**DEVIATION REQUEST
 AND DECISION FORM**

Project Name : Grandwood Ranch
 Schedule No.(s) : 6119000003
 Legal Description : S2N2, EX PT TO HIGBY RD CONV BY REC# 205092691 W/MR SEC 19-11-66

DEVIATION NO. 4 (Rev. 4/17/2020) - A deviation from the standards of or in Section 2.3.2 of the Engineering Criteria Manual (ECM) is requested for the proposed extension of Furrow Road from Minglewood Trail to Higby Road (a proposed Rural Major Collector per the MTCP). Please refer to Deviation Exhibit 4.

GRANDWOOD RANCH DEVIATION REQUEST EXHIBIT

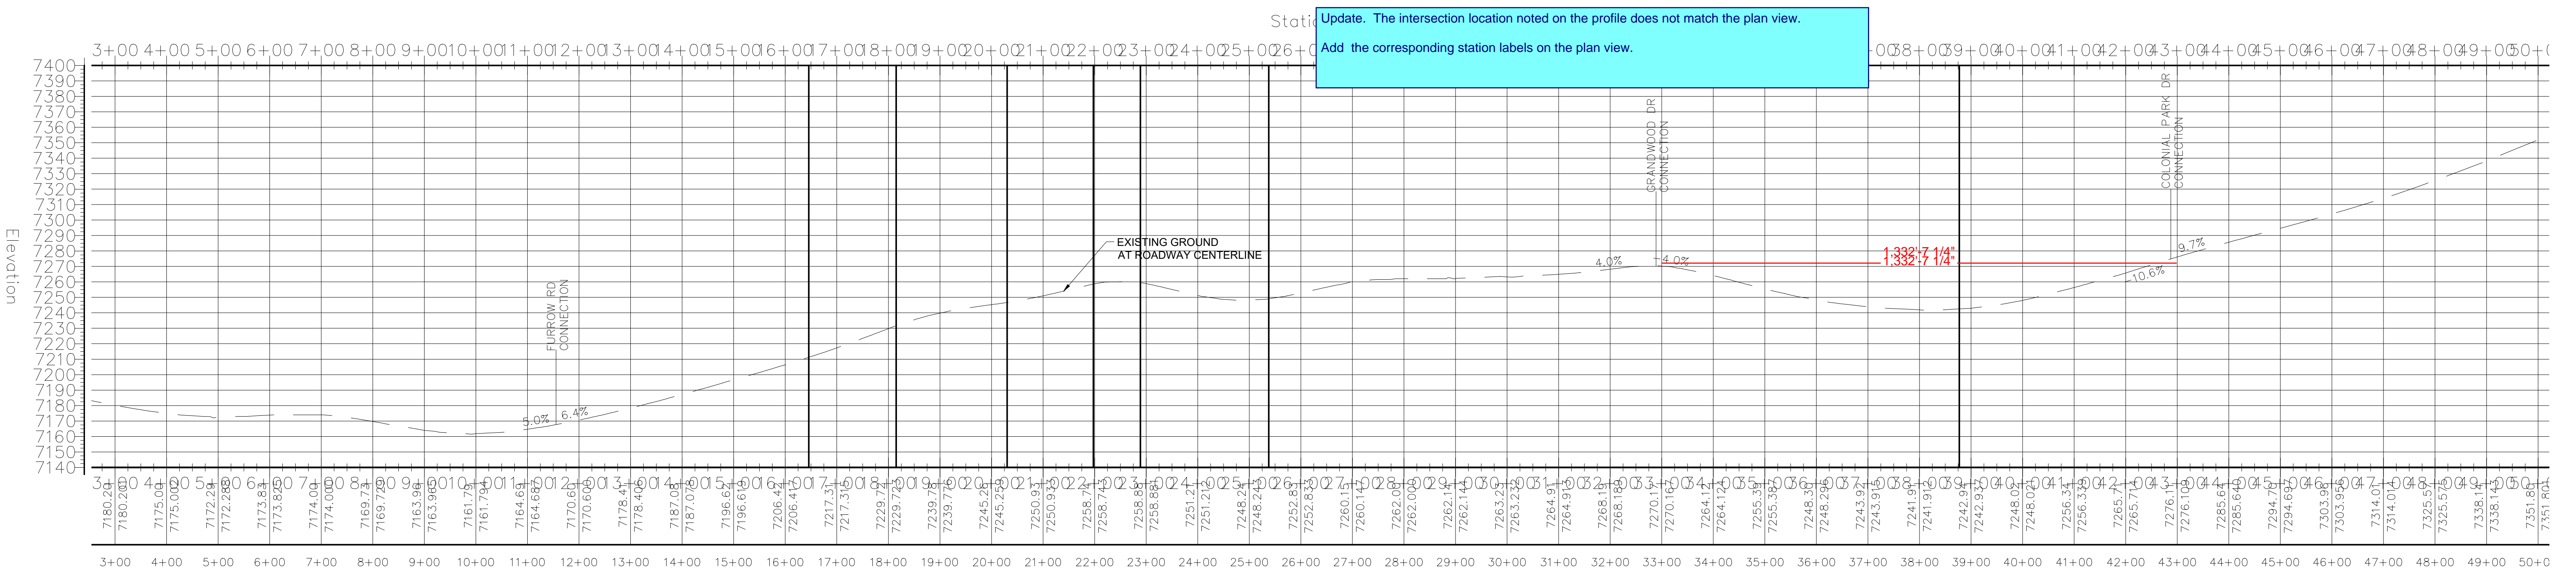
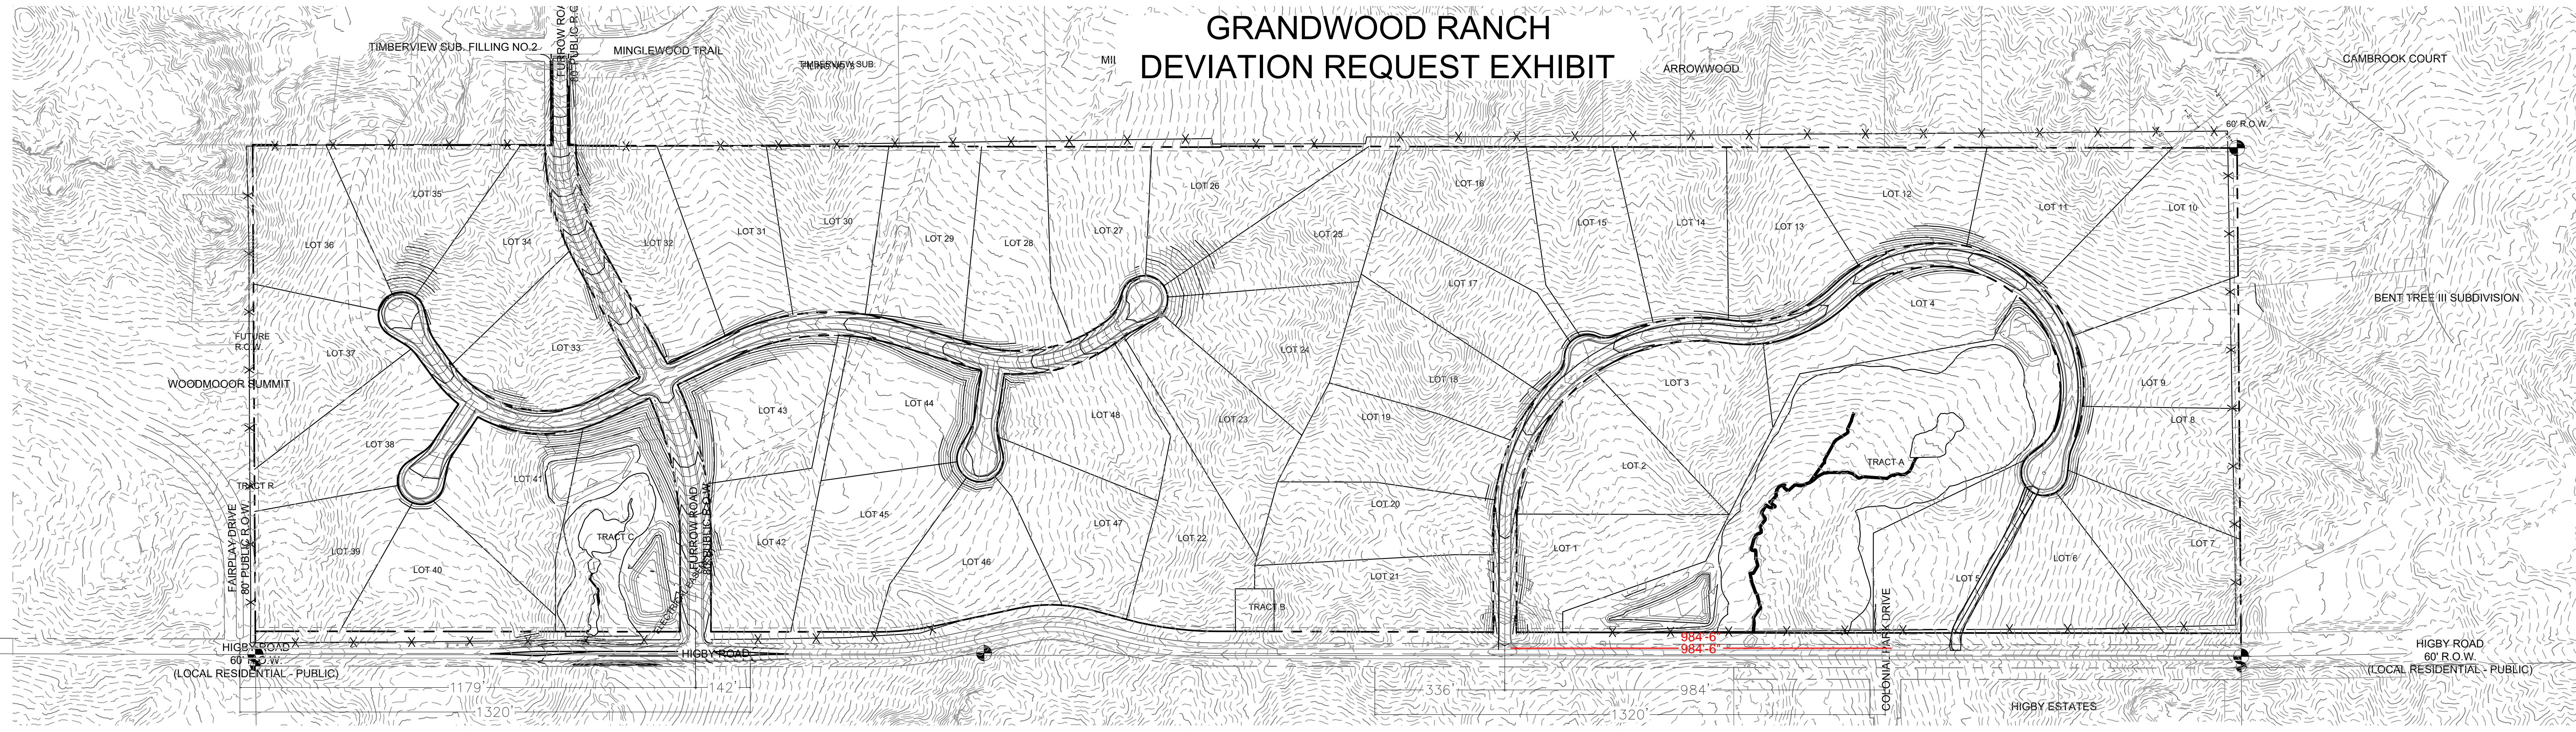
Update. The intersection location noted on the profile does not match the plan view.
Add the corresponding station labels on the plan view.
